The **Captain Code**[®] Guide to

2014

NEC[®] Code Changes

Figure 406.3(E) Controlled Receptacle Marking Symbol

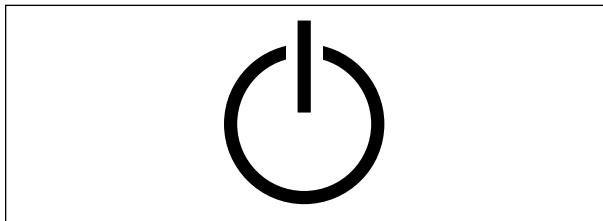
- A new subdivision (E) titled Controlled Receptacle Marking, Exception, and associated figure have been added to 406.3
- This requirement applies to receptacles controlled by building automation or energy management systems
- A specific power symbol marking must be applied to nonlocking type, all 125-volt, 15- and 20-ampere automatically controlled receptacle outlets and be visible after installation

(E) Controlled Receptacle Marking. All nonlocking-type, 125-volt, 15- and 20-ampere receptacles that are controlled by an automatic control device, or that incorporate control features that remove power from the outlet for the purpose of energy management or building automation, shall be marked with the symbol shown in Figure 406.3(E) and located on the controlled receptacle outlet where visible after installation.
